TECHNICAL SERVICE BULLETIN

TSB#: 16-042

2017 North Point FW

Technical Service Bulletin Notification TSB #16-042

Fig 1

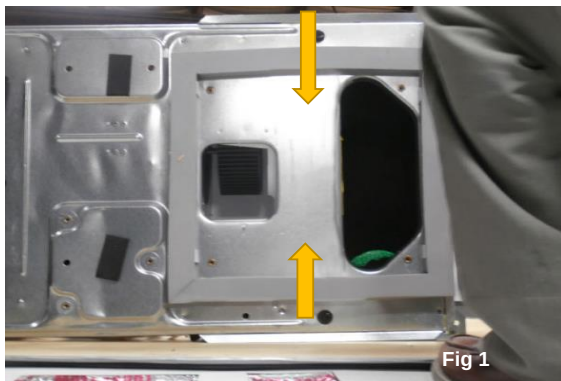
- 2 **Fig 1:** Clean area between ducts of air conditioner with alcohol, dry.
Fig 2: Remove air conditioner gasket, Clean surface with alcohol, dry.
Install new air conditioner gasket.

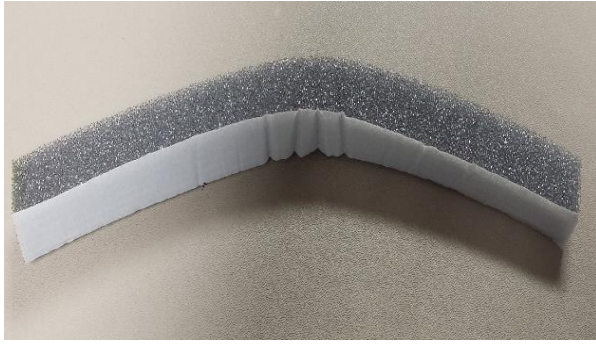
3 Fig 3: Remove the backer from the foam piece.

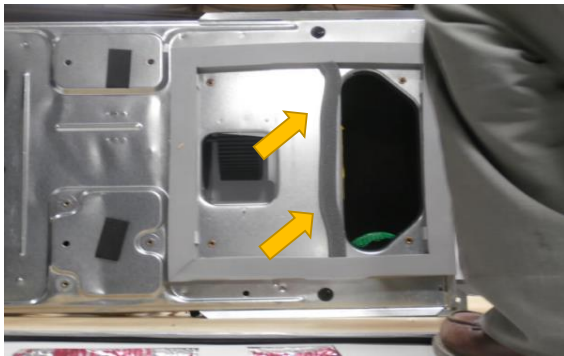
Fig 4: Place foam piece over area between ducts on air conditioner.
Press into place.
